# SHARP TELEVISION TECHNICAL BULLETIN

#### MODEL 66GS62H

#### East/west faults

**R610**

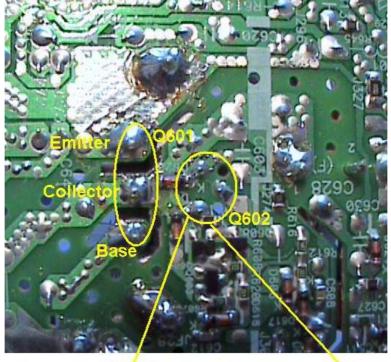
When fault finding in the east/west drive circuit, it is often found that one of the SMD diodes is faulty, normally caused by failure of Q602. When replacing Q602 be careful not to accidentally wipe R610 off the board. R610 is in the control circuit and if it is missing, Q602 will never turn on. It is possible for any of the three driver transistors to fail (Q603, Q604 and Q608). It is recommended that if any of these transistors are suspect that all three are replaced together.

**New Q610 Transistor**

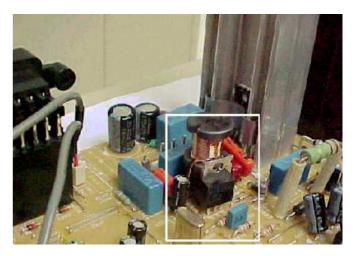
A number of changes were made to the east/west output circuit during production as follows:

- A larger heatsink was used for Q601 and Q602 to help reduce the operating temperature of these devices. The
  original heatsink is 65mm in height; the new one is 110mm in height. If the heatsink has already been changed
  for the larger type, it is not necessary to change it again. See the picture relating to the new Q602 for new
  heatsink.
- 2. Q602 was changed for a more powerful device.
- 3. The inner pincushion correction transistor, Q610 was up rated from a SMD device to a wire ended type. The new transistor is now mounted on the component side of the PWB. If a set comes into the workshop, and this resistor has not been changed, it is advisable to do so, using the part number for Q610 given below:

Circuit Diagram of the GA10 East/West Stage

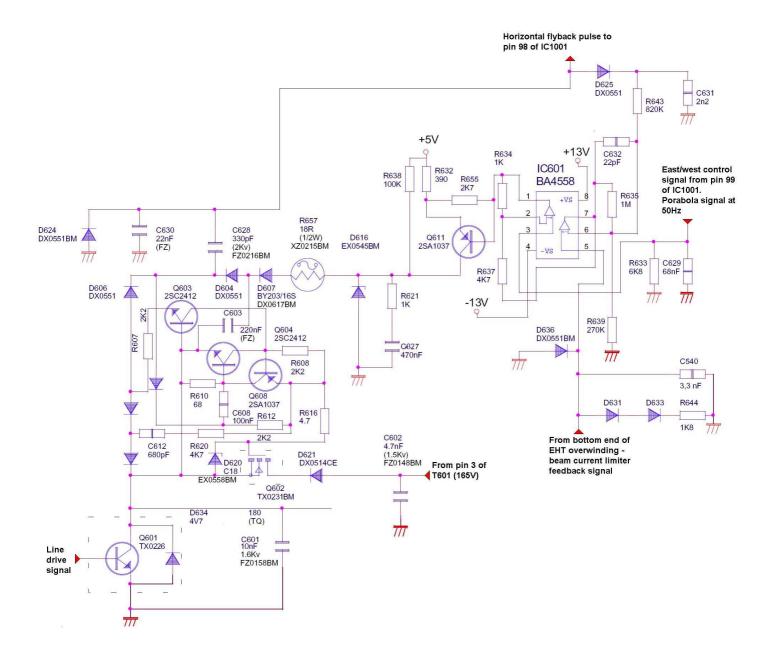
When the set starts up, there is no east/west correction; therefore Q602 will not be turned on. As Q602 needs to be turned on, there is a small circuit that provides this function. R638 ( $100k\Omega$ ) is connected to the +5V line which connects to the gate of Q602 via R657, D607, D604, D617, R612 and R616, pulling it high and turning it on at start up. When the set is running, the east/west control signal keeps turning Q602 on when necessary.

If it is suspected that there is a fault with the drive to Q602, not allowing it to turn on at start up, short out the source to drain of this device and turn on. Note that the picture will be extra large when this is done. The next step is to see if the driver circuit is faulty. Disconnect R657 (D616 end) and apply 2.5V from a DC power supply to this end. When the set is turned on, it should start up. If the voltage is varied between about 1.5V and 4.5V, the width should vary. If it does not there could be a problem with the drive circuitry. Another component that will cause this fault is the line output transistor. If it has been replaced with a BUH515, the flyback pulse will not be high enough to provide any east/west correction. It is therefore very important to ensure that a BUH515D is used in Q601 position. This device must be ordered from Sharp Parts Centre as it has been known for transistors supplied from other sources not to work, or work incorrectly.
